# Statement of Environmental Effects

## SECTION 4.55

83 Parkes Road Collaroy Plateau .

## **AMENDMENTS AS PER SECTION 4.55 (LOT 101)**

PREVIOUSLY APPROVED

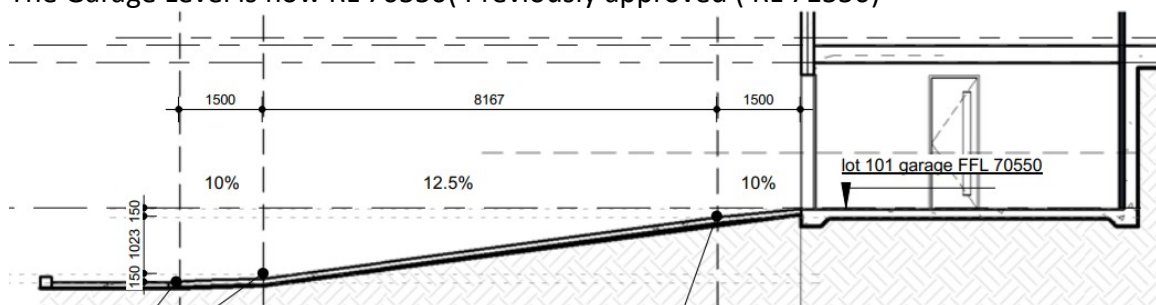
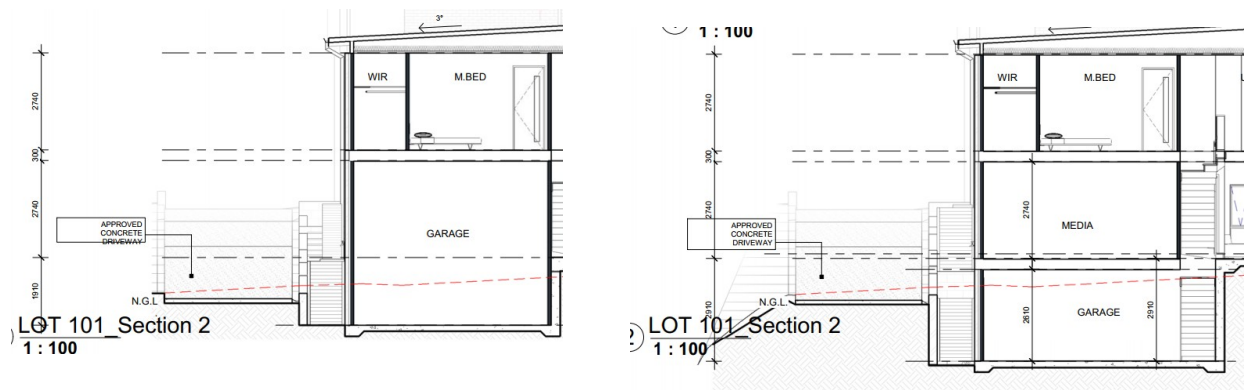
- 1.MEDIA ROOM ADDED ABOVE GARAGE LEVEL
- 2.TWO MORE WINDOWS ARE ADDED AT MEDIA ROOM'S FRONT WALL
- 3.DRIVEWAY UPDATED

As per the new application Clients are requesting to reduce the Driveway Gradient for Lot 101 .

The Garage Level is now RL 70550( Previously approved ( RL 71550)

The Proposal has reduced the Driveway gradient from 24% to 15% and has made more use of space efficiently.
